MODEL 504 .22 HORNET

MODEL 504 CENTERFIRE

M/504 CENTER FIRE .22 HORNET

M504 CENTER FIRE MAGAZINE BOX

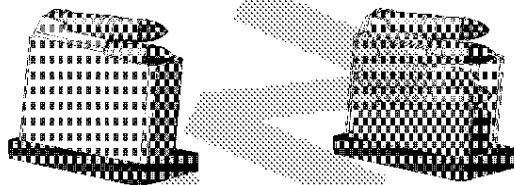
4-Round detachable magazine box

**M504 CENTER FIRE
FIRING PIN ASSEMBLY**

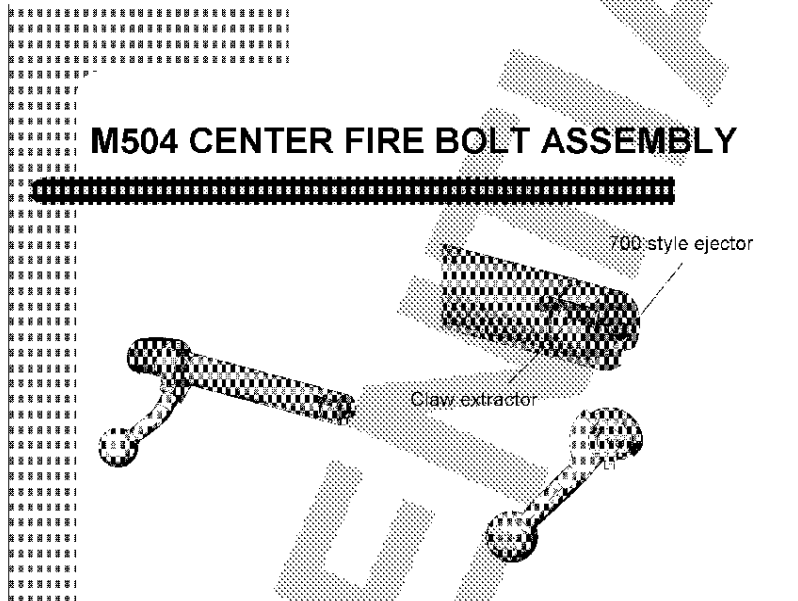
New firing pin & main spring utilizing
the same M504 rimfire design

- Initial 100 rd proof test complete
 - Head space did not move during test.
 - The Firing Pin was piercing 90% of primers.
 - Firing Pin design was changed to incorporate a smaller, round firing pin tip.
 - A second 100 rd proof test will be conducted with the new firing pin.
- Drawing package complete on June 9th.
 - sent to Mayfield for review.
